## Product Change Notice : ES E-xx Series Electromechanical Detector Switches

PCN.PG 13.6.14.2021

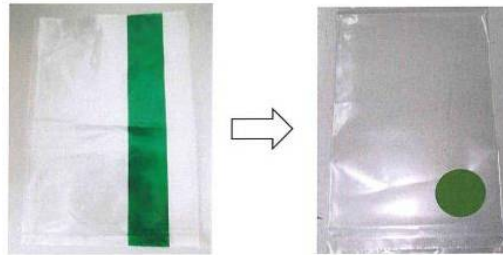
Panasonic currently use a plastic bag with a green stripe for shipment. Due to insufficient supply from suppliers, the shipment requirements cannot be met. Hence, we will change the plastic bag with green stripes to an alternate plastic bag with a green circle. The new plastic bag and the original plastic bag are both normal shipping plastic bags and have the same size and suppliers. This change will not have any effect on production and will make no change of the product.

Green stripe plastic bag

Green circle logo plastic bag

The plastic bag package will switch back to the green stripe from July 31, 2021.
